FAQ Number 13-0002

FAQ Title Modeling of Main Control Room Abandonment on Loss of Habitability

Date: 3 July 2013

To clarify the expectation for modeling of control room abandonment for fire scenarios in the main control room (MCR) that lead to a loss of habitability.

Figure 1 - Flow Chart for Abandonment Due to Loss of Habitability (LOH)

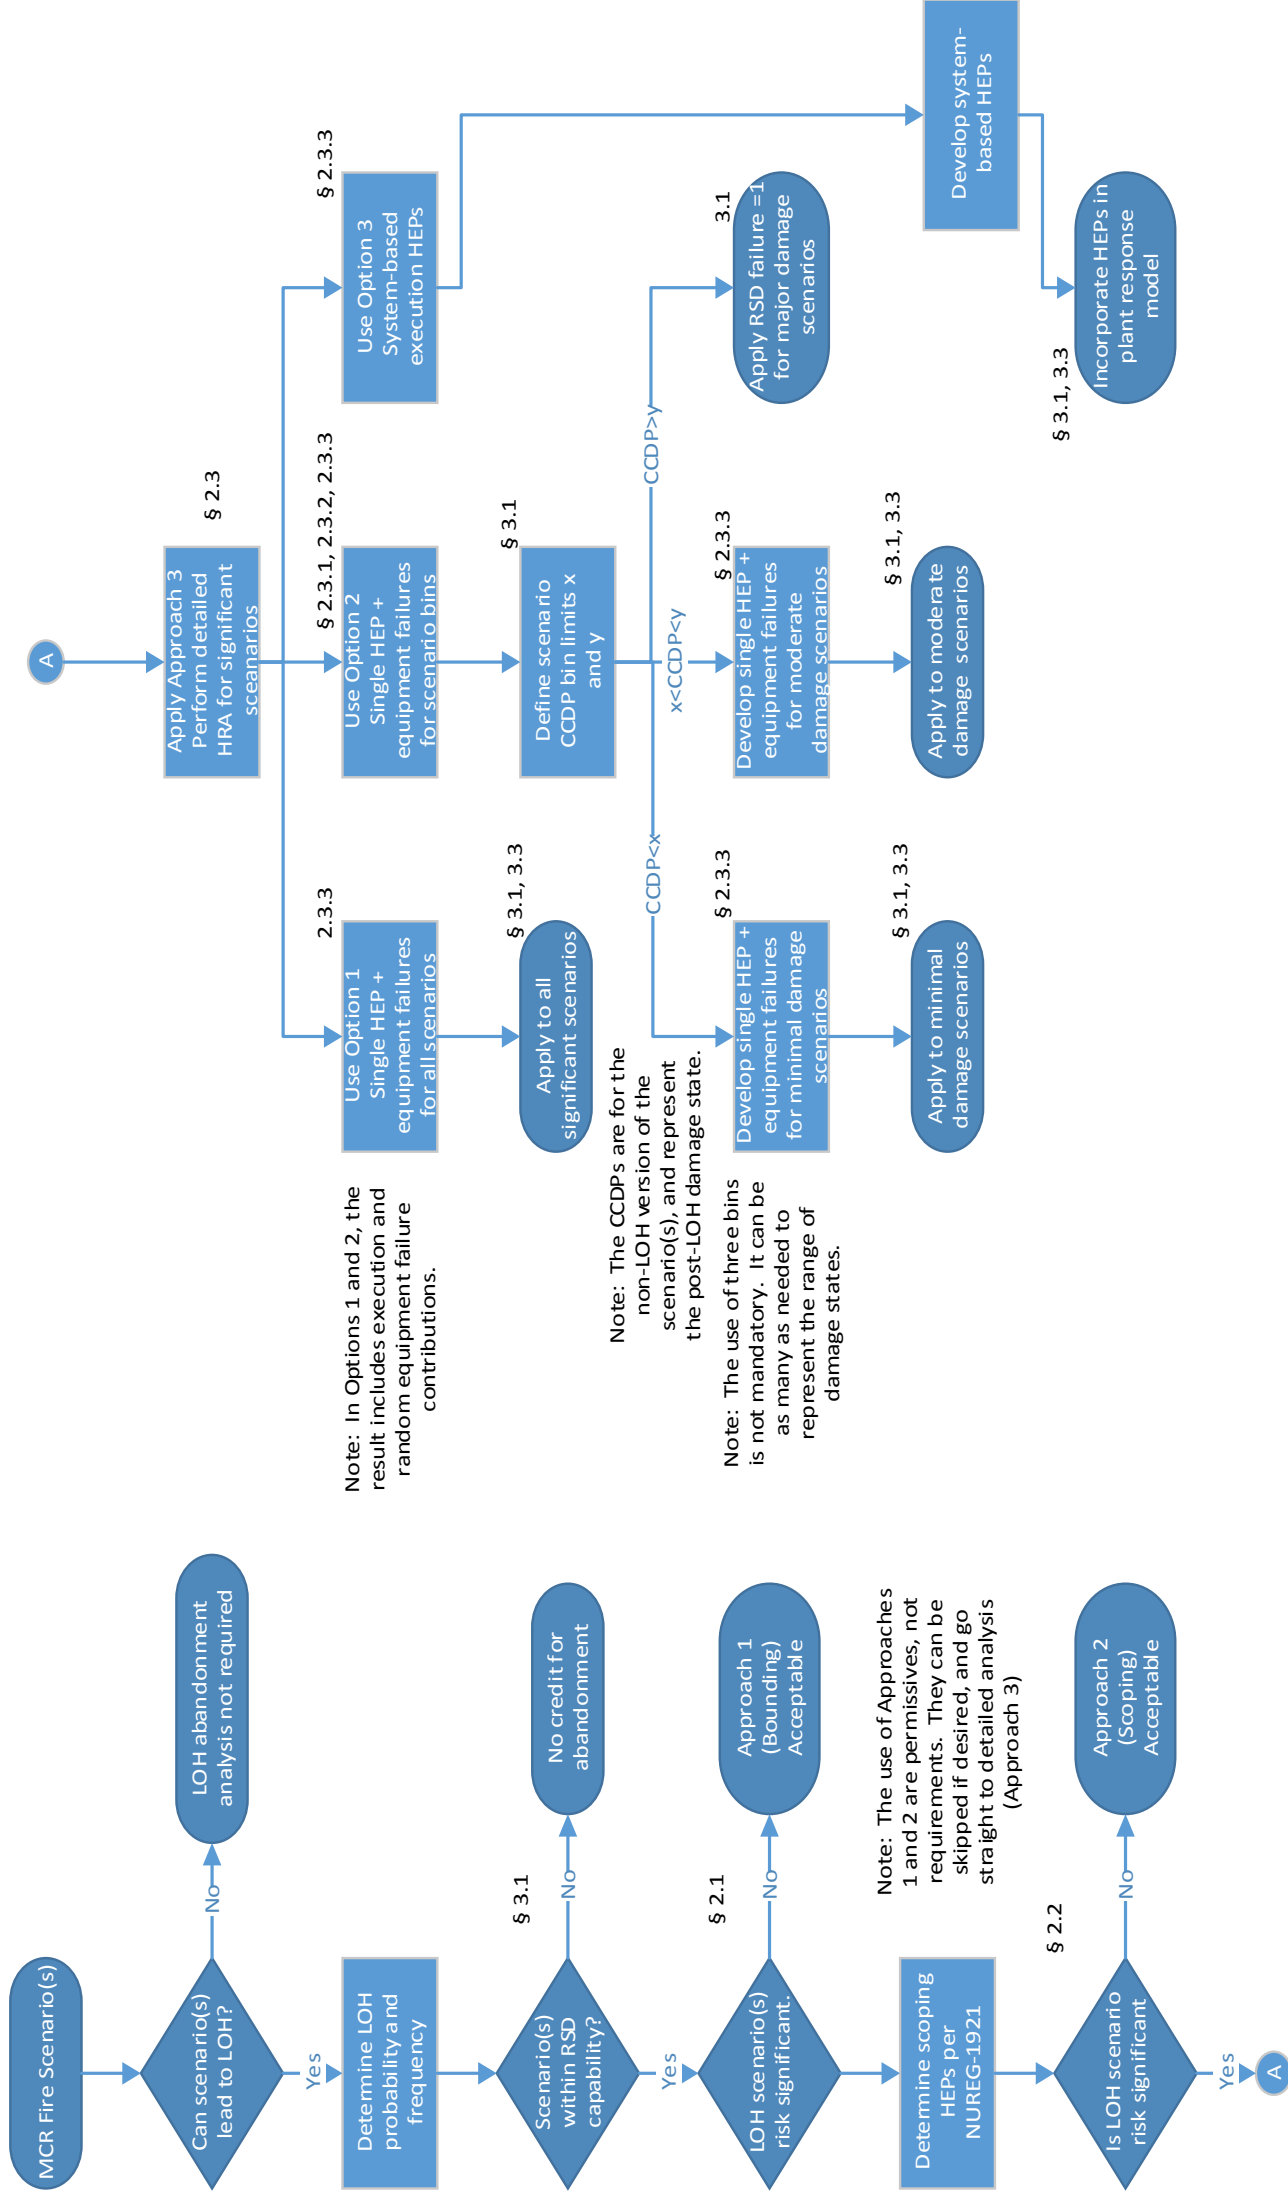
Comment [06]: We need to have discussion regarding the figure. It's not clear first of all, why a single HEP constitutes a detailed HRA analysis. We need to understand the rationale here. Secondly, the discussion under Option 2 of Approach 3 seems to be overblown. We do not understand the need for such a complex addition to the table.

Comment [O13]: Again, we're not sure of the how behind developing the single HFE. Need to understand as discussed earlier with regards to the figure. The PRA Standard says that detailed analysis needs to address the scenario specific aspects that influence operator actions.

Comment [O22]: Prior comment on detailed analysis. Need to understand how you're doing this. Are you estimating HEPs for scenarios and somehow rolling them up into a single value? Or is the intent to establish a single HEP in another fashion? How are equipment failures treated?
